**V2500-A1/A5 SERIES PROPULSION SYSTEMS SERVICE BULLETIN**

This document transmits Revision 1 to Service Bulletin EV2500-71-0162 and  
 Revision 1 to the Supplement

**V2500-ENG-71-0162**  
 Transmittal - Page 1 of 2

POWER PLANT – ELECTRICAL HARNESS – LIGHT DUTY – EEC LINK HARNESS CORE – REVISED  
COOLING AIR DEFLECTOR BRACKET ASSEMBLY FOR ELECTRICAL CONNECTOR AT STAGE 10 ON/OFF  
VALVE

View AB of turbine cooling air valve – Before and after alteration  
Figure 2

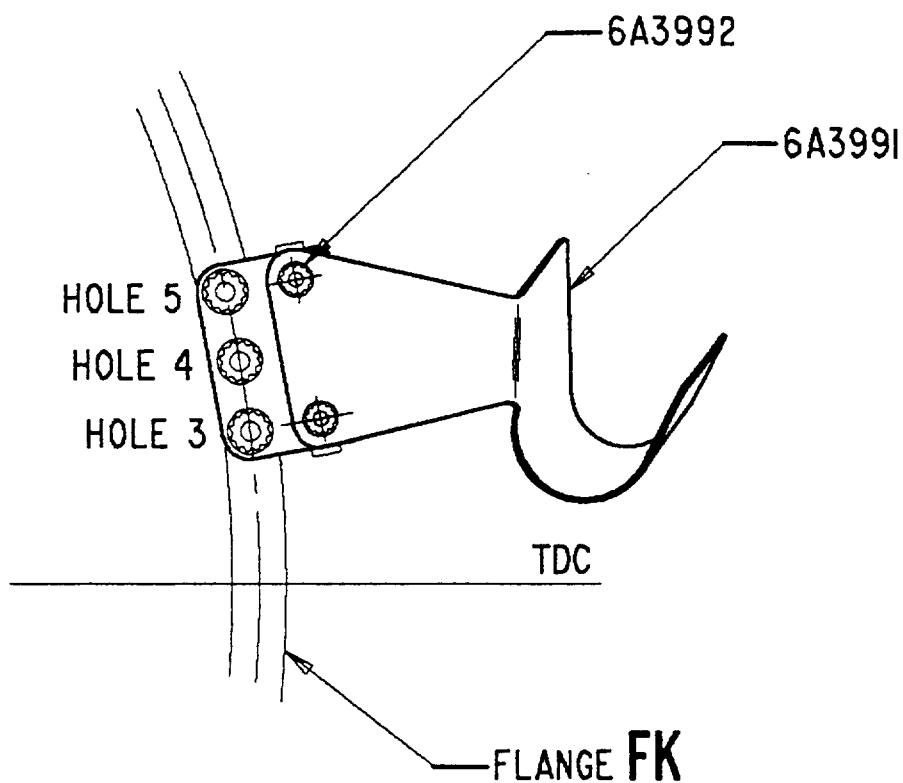
- (a) A revised cooling air deflector bracket is introduced, similar to the existing item except that the fabrication now comprises a deflector, a support and a stiffening web replacing the existing two piece assembly. The support bracket edges are folded and the web is re-profiled to provide an increase in stiffness.
- (b) A revised attaching bracket is introduced similar to the existing item except for folded edges to provide an increase in stiffness.
- (c) The core harness assembly backshell has been turned one tooth (22.5 degrees) anti-clockwise to provide additional clearance with the revised bracket configurations.

Bracket assembly - before alteration  
Figure 3

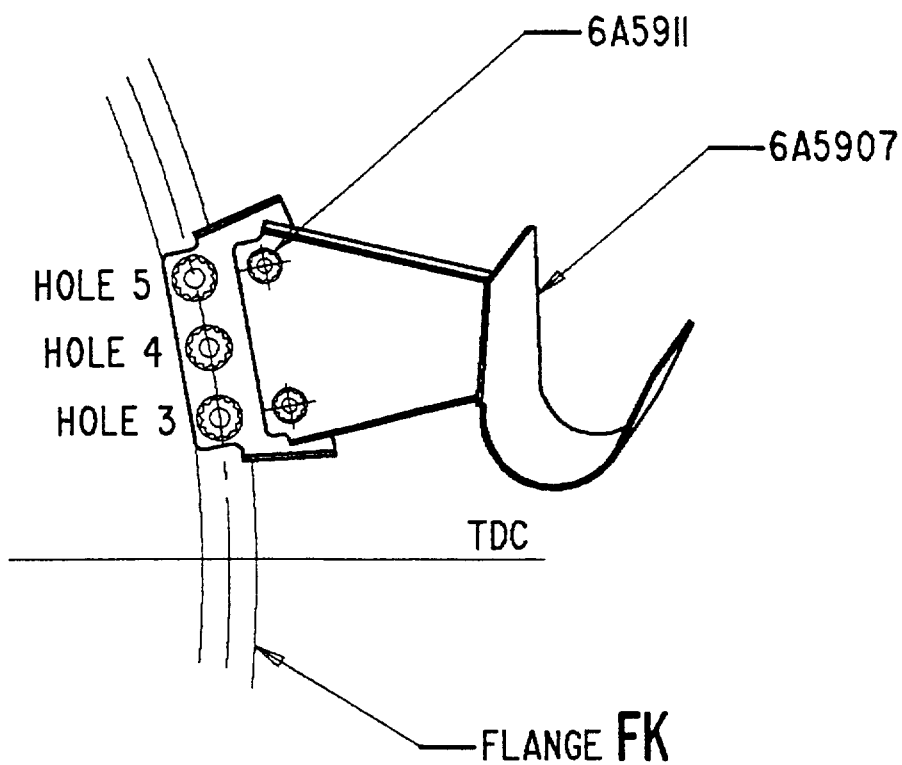
High Cycle Fatigue (HCF) cracking of the core harness cooling air deflector bracket assembly and corresponding stub bracket for the stage 10 on/off valve electrical connector may occur.

The problem is attributed to insufficient stiffness of the current standard of brackets.

View AE of cooling air valve - after alteration  
Figure 5

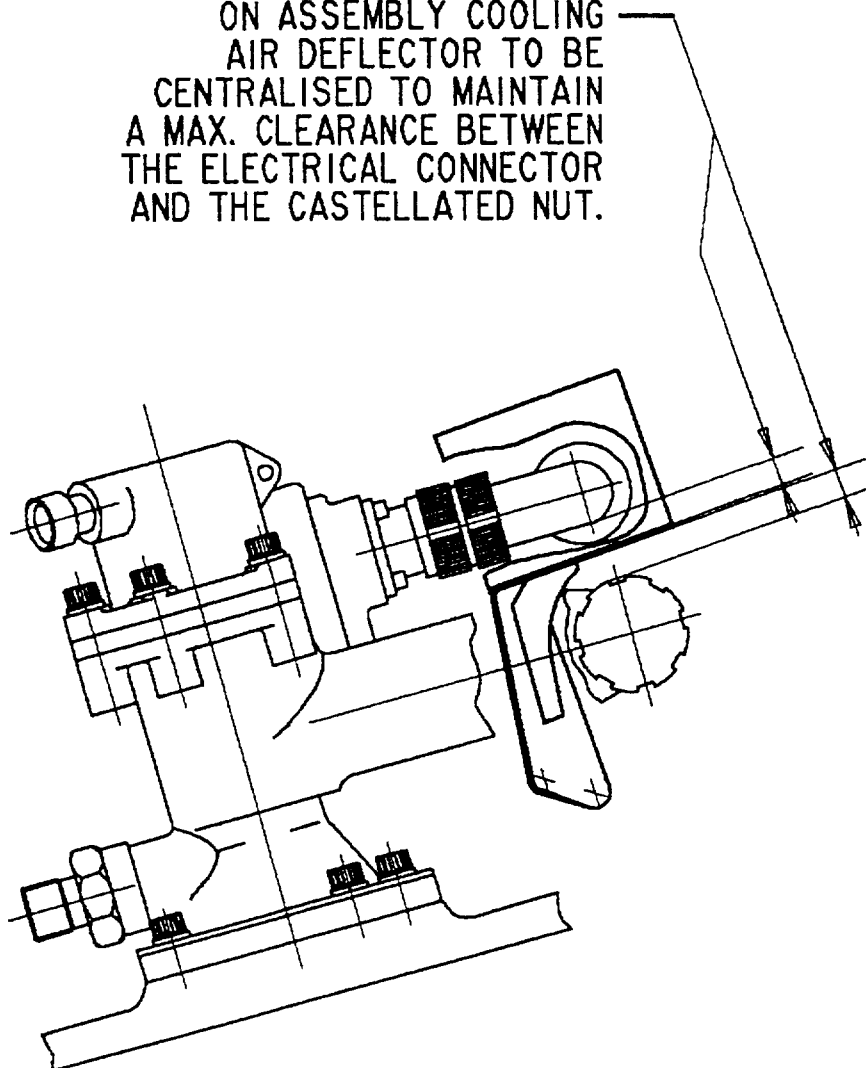
ON ASSEMBLY COOLING  
AIR DEFLECTOR TO BE  
CENTRALISED TO MAINTAIN  
A MAX. CLEARANCE BETWEEN  
THE ELECTRICAL CONNECTOR  
AND THE CASTELLATED NUT.

Rework of harness assemblies  
Figure 6

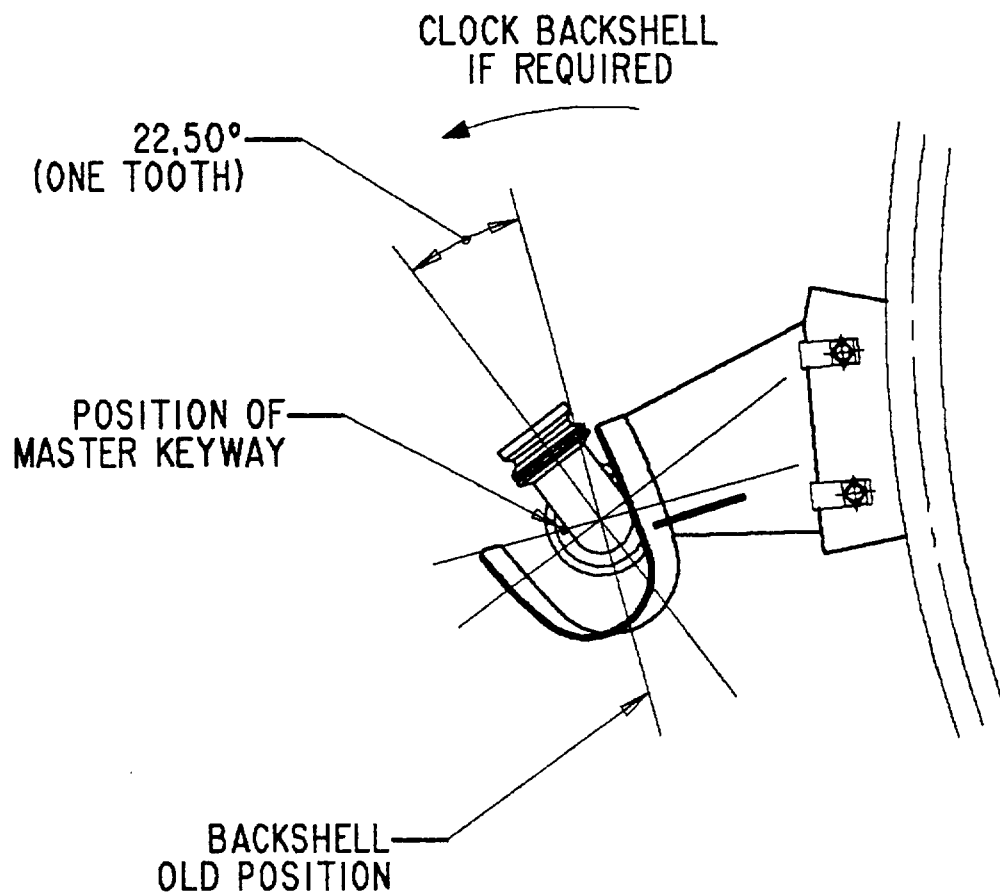
(2) Existing core harness assemblies may be reworked without re-identification (refer to Figure 6).
